Colliery Dam Summary

July 29th 2013

Dr Lorne R Gale

For example – “Armouring”

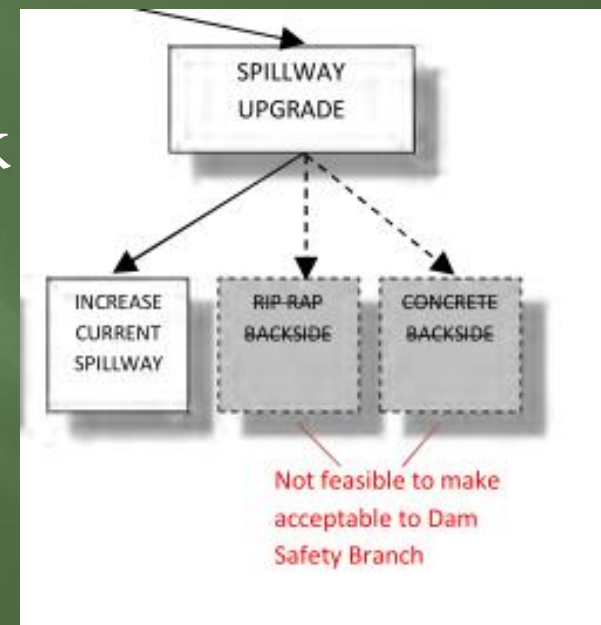
- ❑ 2010 Report said to do this!? (Pg 46 of EBA report)
- ❑ Now not acceptable?
- ❑ Confirmed with DSB last week that this *IS* acceptable.....
- ❑ Possible method to deal with spillway deficiency and large flood events even for the interim

Another option

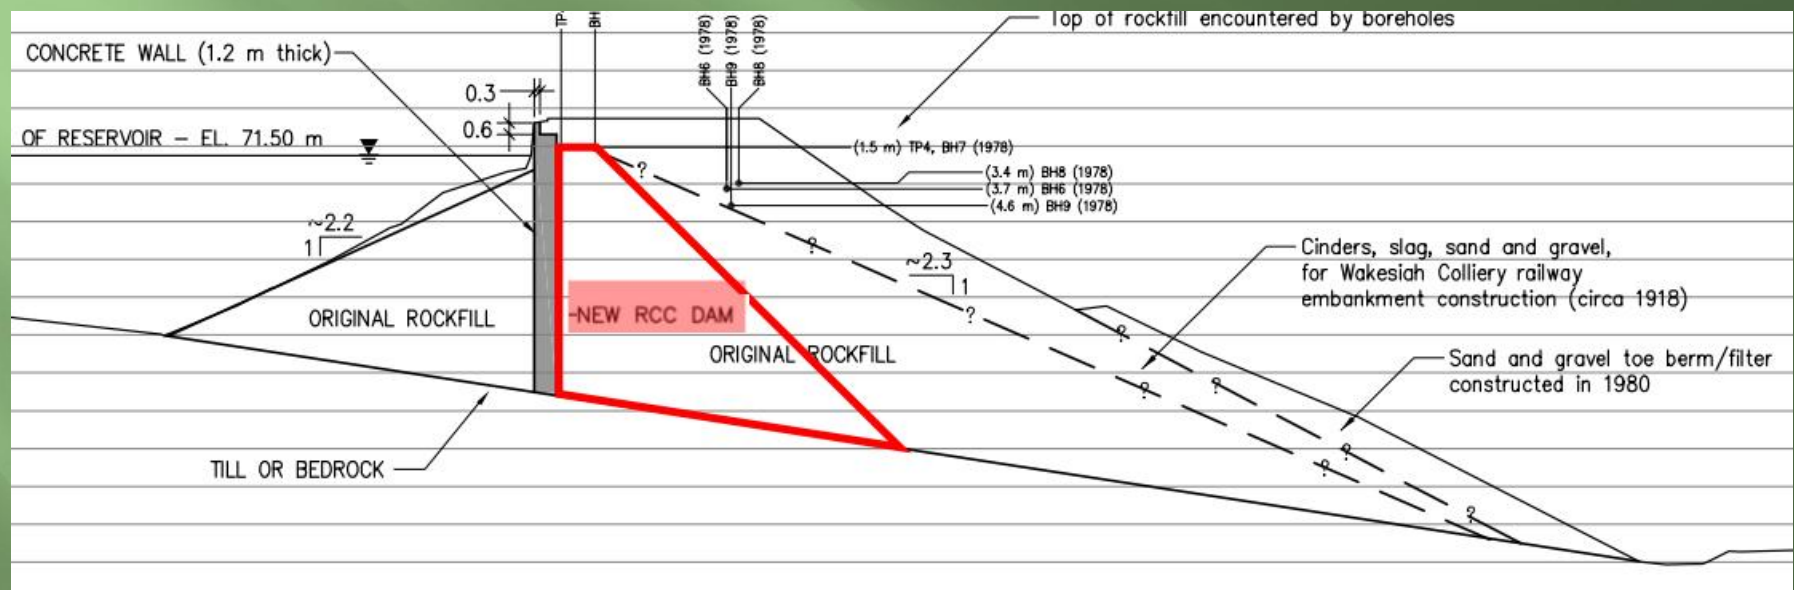
- If backfill is unknown and is the uncertainty then remove up to concrete wall and replace with roller compacted concrete.

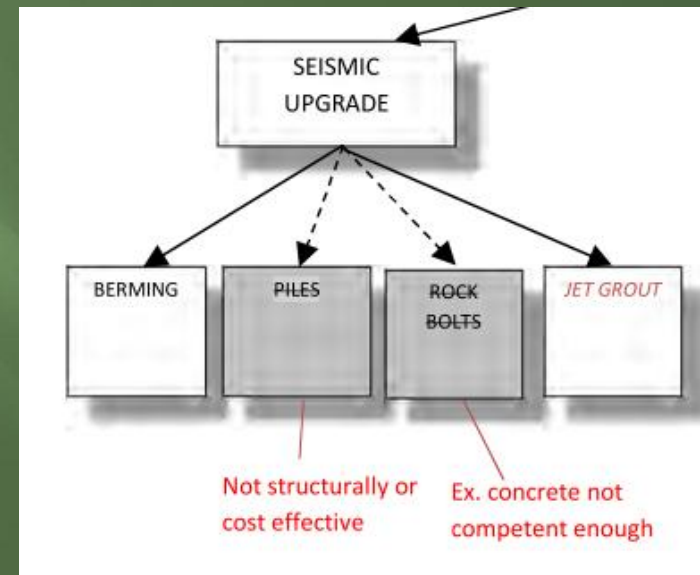
- Or deepen spillways and install spill gates to deal with flood events

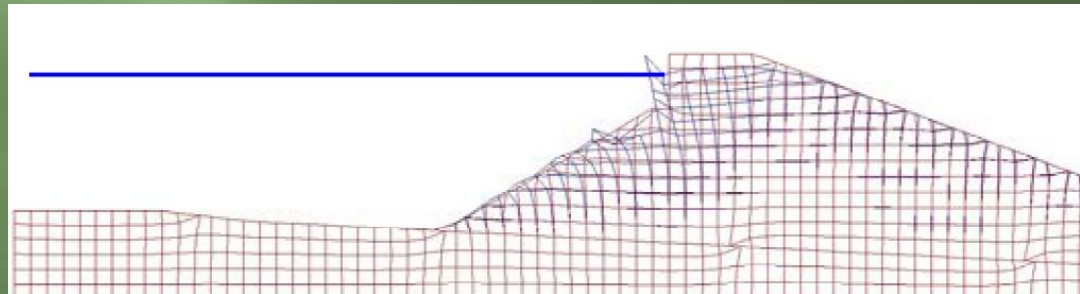
- ❑ Report (pg 36 EBA) indicates that this was not studied.

- ❑ What if water level was reduced then this mode will not occur.....?
